JOB TITLE: CENTRAL FIRE STATION		SHEET TITLE: COMMUNICATION LEVEL- POWER PART PLAN	
HARRIS SHARP & ASSOC., INC. ARCHITECTURE-PLANNING-INTERIORS 2915 W. CHARLESTON BLVD. LAS VEGAS, NEVADA 89102 (702) 877-0125	JOB No. 482-1	DATE 2-8-84	SHEET No. Q-46
	DRAWN RWM	CHECKED G.C.

JOB TITLE: CENTRAL FIRE STATION		SHEET TITLE: CHILLER EQUIP EMERG. SHUTDOWN CONTROL DIAGRAM	
HARRIS SHARP & ASSOC., INC. ARCHITECTURE-PLANNING-INTERIORS 2915 W. CHARLESTON BLVD. LAS VEGAS, NEVADA 89102 (702) 877-0125	JOB No. 482-1	DATE 2-8-84	SHEET No. Q-47
	DRAWN RWM	CHECKED G.C.

Department of Public Works		Engineering Design Division															
CENTRAL FIRE STATION		REVISIONS		AND/OR		CLARIFICATION		Scale (h)		Scale (v)		W.A.							
								Fid. bk. no.		Date									
								Design by		Drawn by

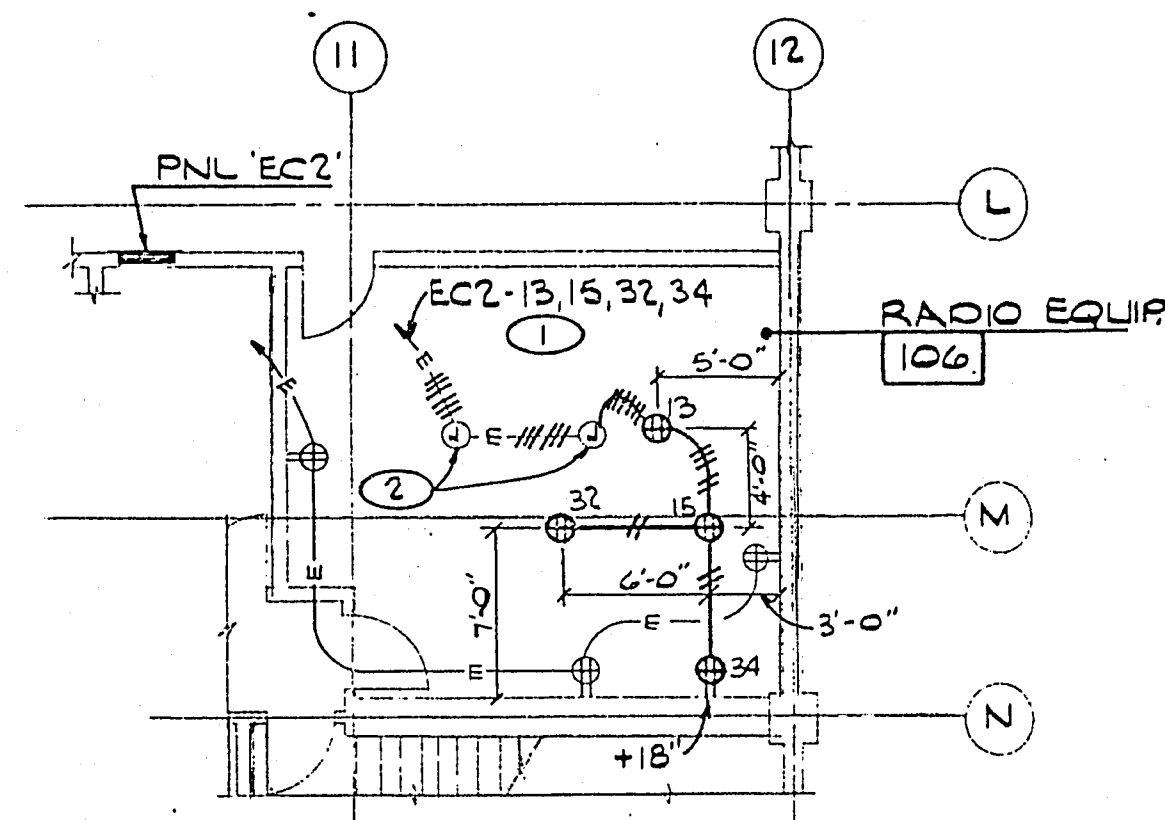
- ① PROVIDE 1P 20A. C.B. IN EXIST SPACE FOR NEW CKTS AS INDICATED.
- ② REMOVE DBL DUPLEX, PROVIDE BLANK COVER PLATES AND PROVIDE NEW OUTLETS AS INDICATED.
